NOTICE OF NON-PERFORMANCE

INSPECTION REPORT

Electrical Corporation:	Southern California Edison Company
Report Number:	PAD_SCE_YLO_20260617_0938
Inspector:	Yana Loginova
WMP Year Inspected:	2025
Quarterly Data Report (QDR) Referenced:	Quarter 4 (Q4)
Inspection Selection:	Energy Safety viewed the contents of the Q4 QDR and performed an analysis that resulted in the selection of the WMP initiatives and locations referenced in this report.
Relevant WMP Initiative(s):	8.1.3.1 - Distribution Detailed Inspections and Remediations (IN-1.1)
Date of Inspection:	June 17, 2026
City and/or County of Inspection:	Corona, San Bernardino County
Inspection Purpose:	Assess the accuracy of Southern California Edison Company’s QDR data, completeness of its work, and performance of WMP requirements.

Deficiency 1

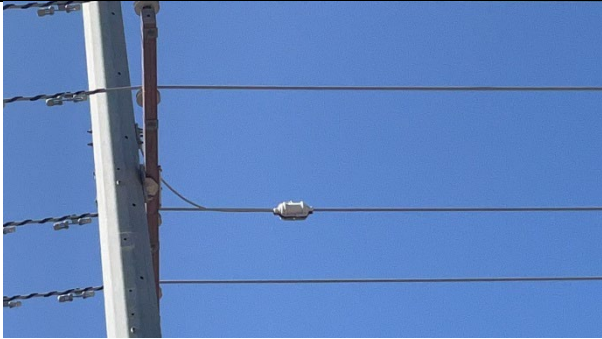
In the 2025 Q4 Quarterly Data Report Submission, Southern California Edison Company reported that work on Distribution Remediation was completed at Structure ID 4818186E, Grid Hardening ID 414446525-4818186E at 8364-8396 Chino Corona Rd, Corona, CA, 92880, 33.9459558727957, -117.62203775654. At this location, the inspector observed that tap cover was unsecured and bare wire was exposed. The inspector's observation is documented in Deficiency 1 photographs, which are attachments to this report. Photo numbers Asset Image 1, Asset Image 2, Asset Image 3, Asset Image 4, Asset Image 5, and Asset Image 6 depict unsecured tap cover and exposed bare wire.

1. Southern California Edison Company's 2025 Q4 Quarterly Data Report Submission reported that work related to 2025 WMP initiative number 8.1.3.1 Distribution Detailed Inspections and Remediations was complete at this location.
2. The original notification at issue at this location identified that remediation of exposed bare wire due to a missing bare tap cover was required.
3. Although the work was reported as complete by SCE, the inspector observed that the tap cover was unsecured and bare wire was exposed upon inspection.

Asset Image 3: View showing unsecured tap cover and exposed bare wire

Deficiency 1. Energy Safety observed that in implementing 2025 WMP initiative 8.1.3.1 - Distribution High Fire Risk-Informed (HFRI) Inspections and Remediations (IN-1.1), SCE failed to complete remediation related to a tap cover on Structure ID 4818186E, Grid Hardening ID 414446525-4818186E at coordinates 33.9459558727957, -117.62203775654. Energy Safety considers this non-performance to be in the Minor risk category. SCE must complete a corrective action for this deficiency by 12 months from the date of this notice.¹
